March 24, 2014

NOTICE OF ADDENDUM
ADDENDUM NO. 1
CONTRACT NO. 7206

STATE STREET RECONSTRUCTION
ASSESSMENT DISTRICT 2014

1 PLANTING PLAN - 800 BLOCK
PL2 1"=20' @ 11X17

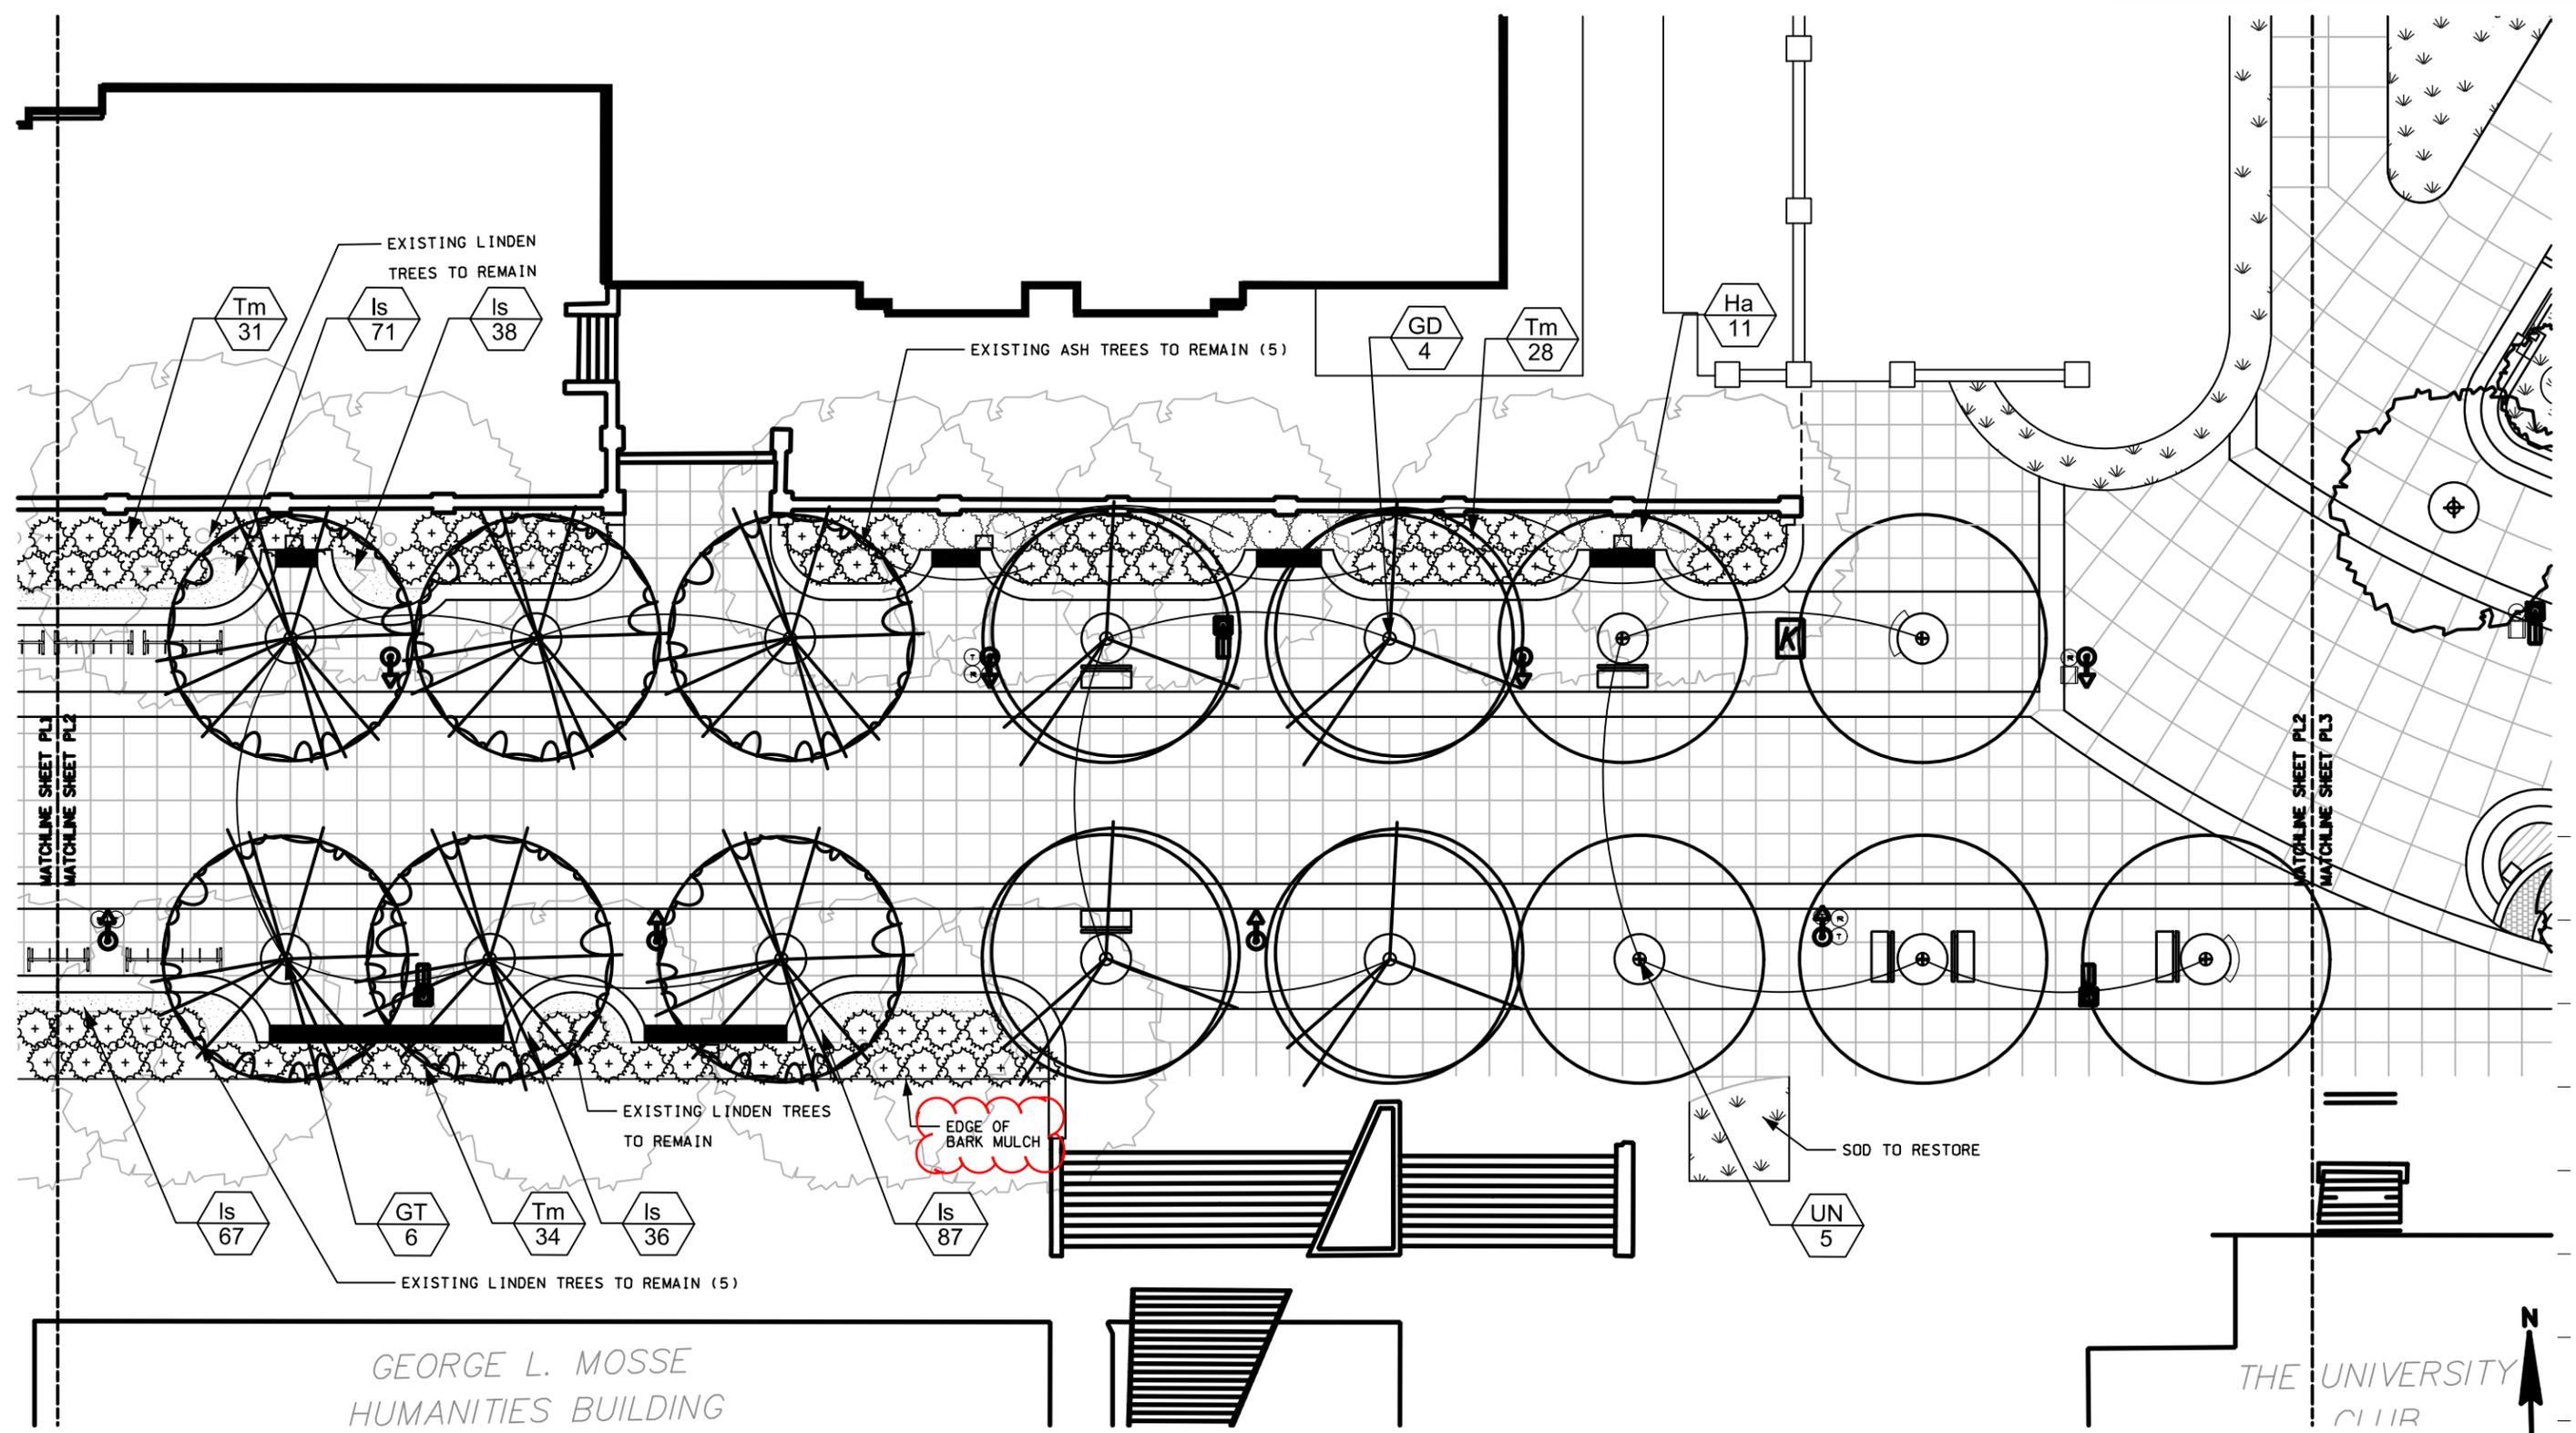
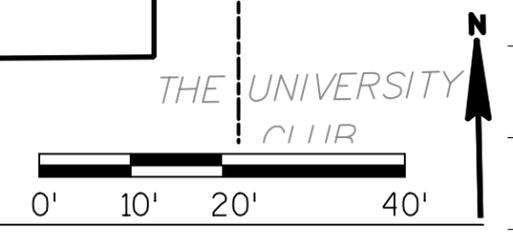
Replace Sheet PL2 (Revised 3/19/14) – Added limits for Bark Mulch item.

Revised 3/19/14 - Added Note

1 TREE PLANTING
PL6 1"=1'-0"

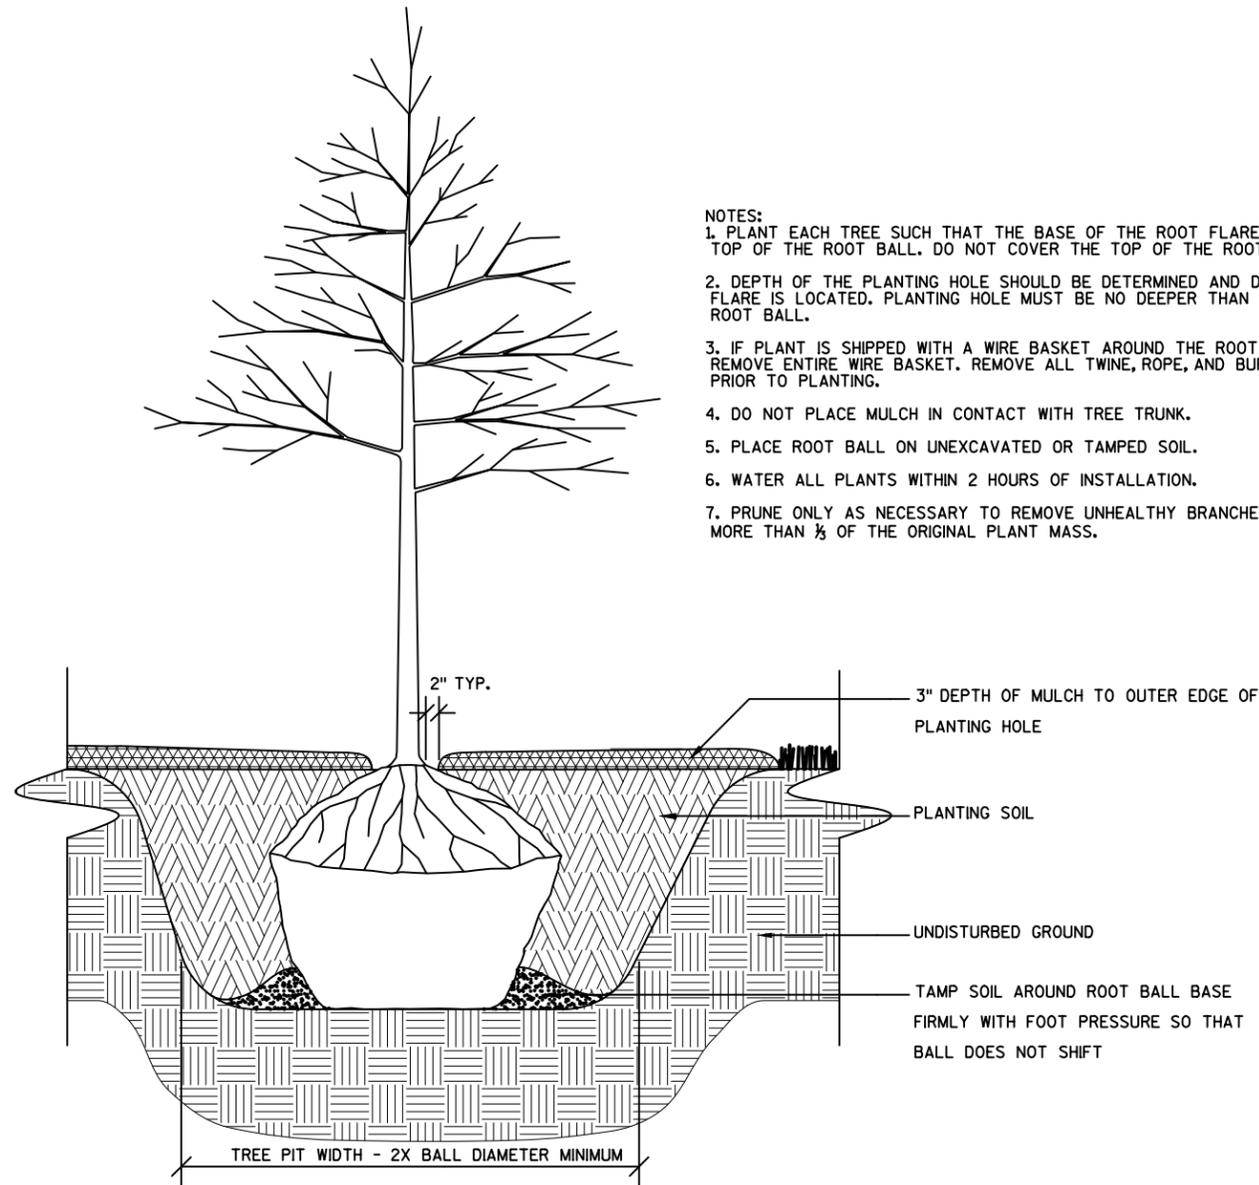
Replace Sheet PL6 (Revised 3/18/14) – Updated planting detail – added depth of mulch (3”).

Revised 3/18/14 - Revised Note

TREE PLANTING - TREE GRATE CONDITION
SCALE: NONE

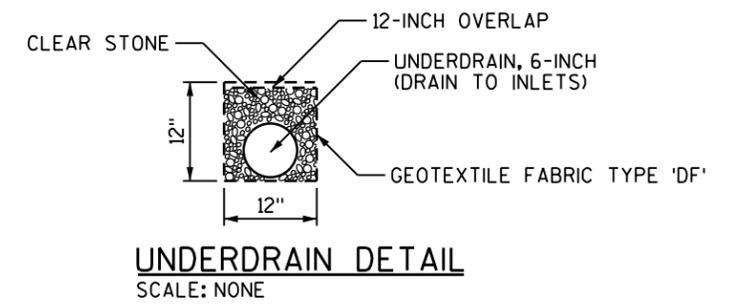
Replace Sheet PL7 (Revised 3/18/14) – Updated tree planting detail – added Geotextile Fabric Type DF.

Revised 3/18/14 - Added Geotextile Fabric

Install tree grates according to manufacturer's instructions and as shown on the details to provide installation on a true, flat plane. Provide 3" depth of washed stone for the entire area of the tree grate. Separate the washed stone from the planting soil mixture with Geotextile Fabric Type DF.

STORM SEWER REMOVAL SCHEDULE

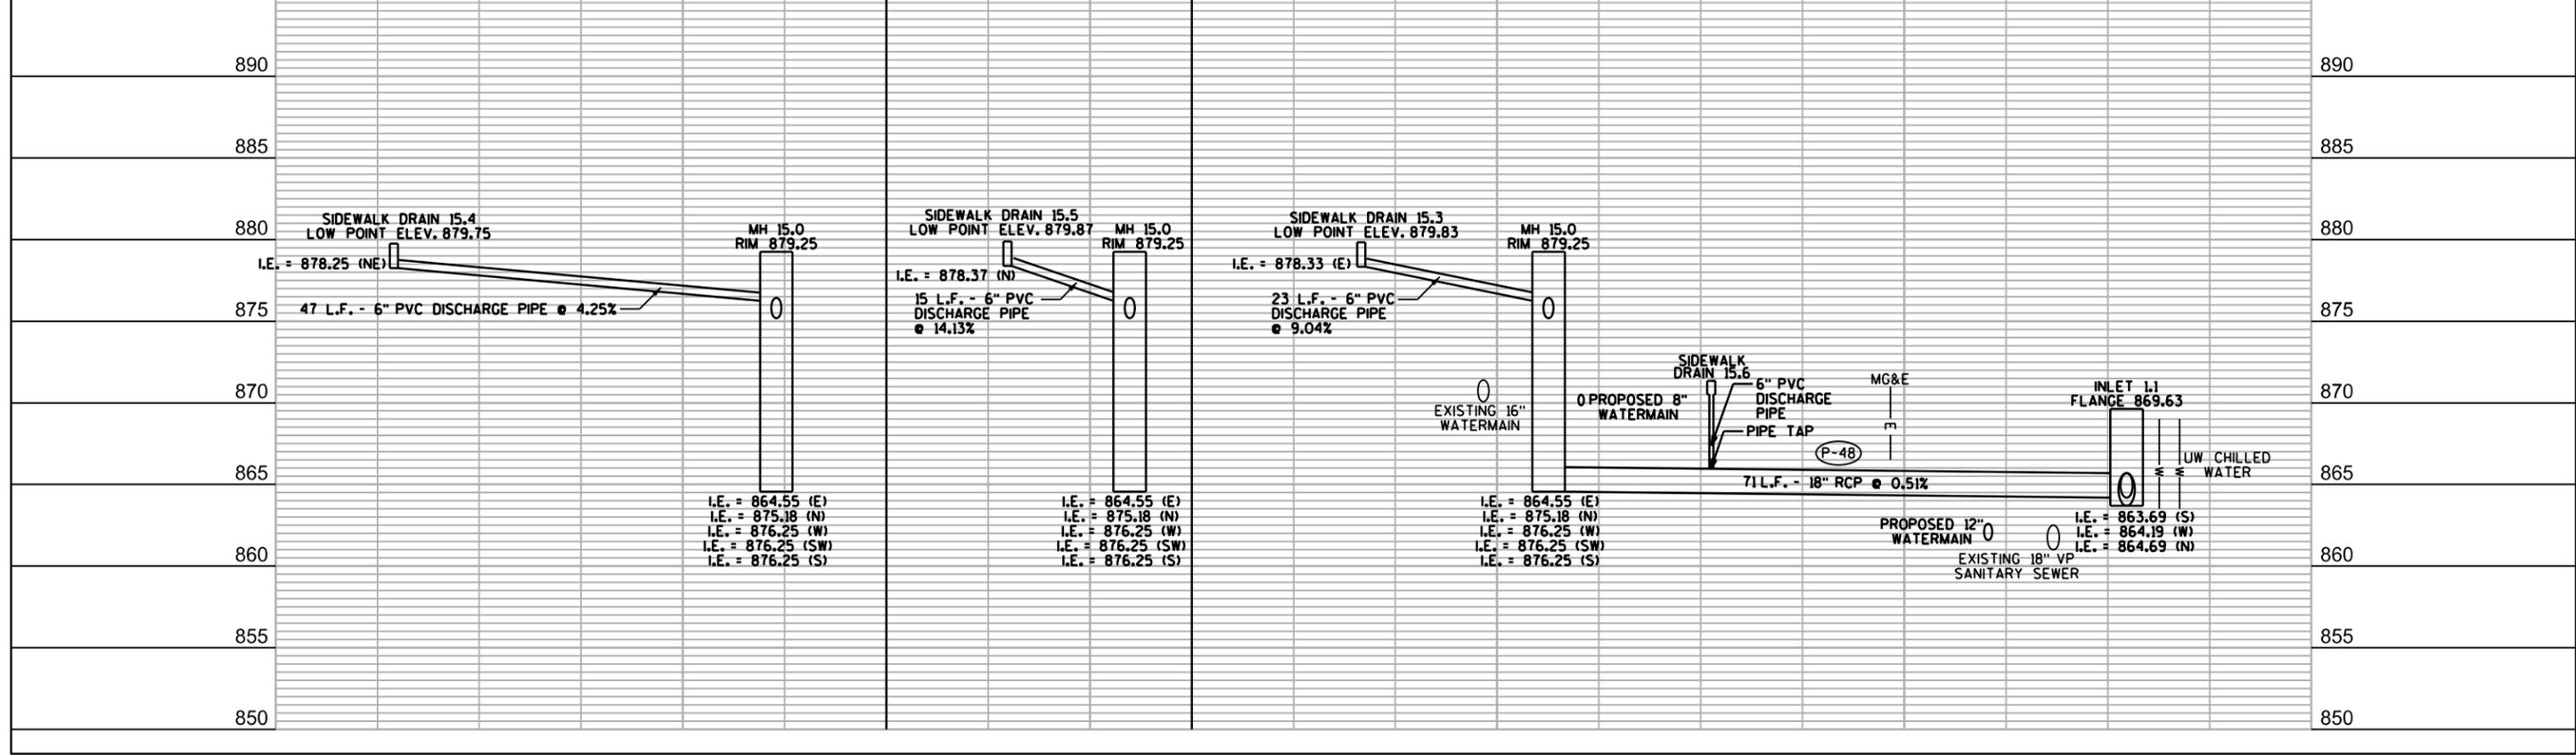
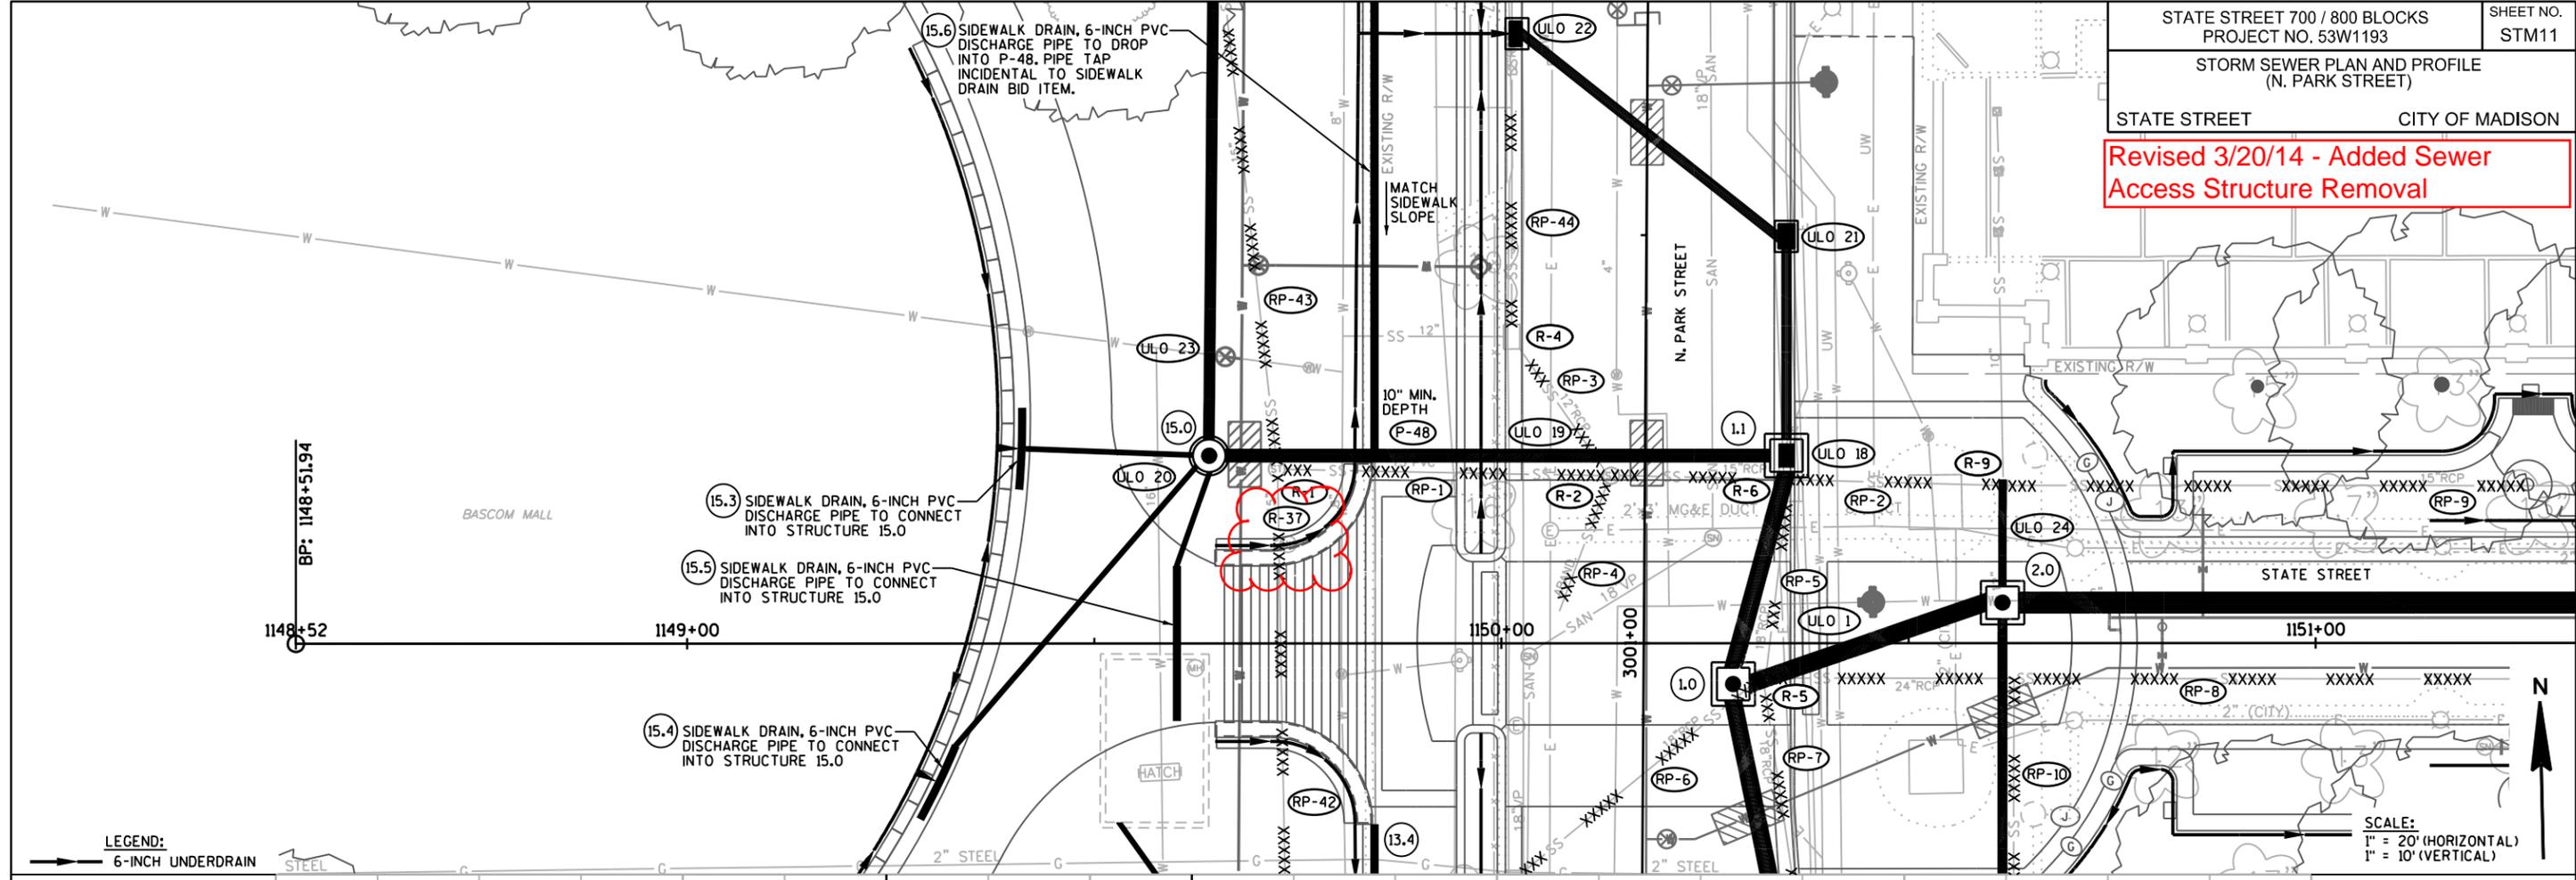
Replace Sheet STM11 (Revised 3/20/14) – Add remove sewer access structure.

Replace Sheet STM14 (Revised 3/20/14) – Add remove sewer access structure.

Revised 3/20/14 - Added Sewer Access Structure Removal
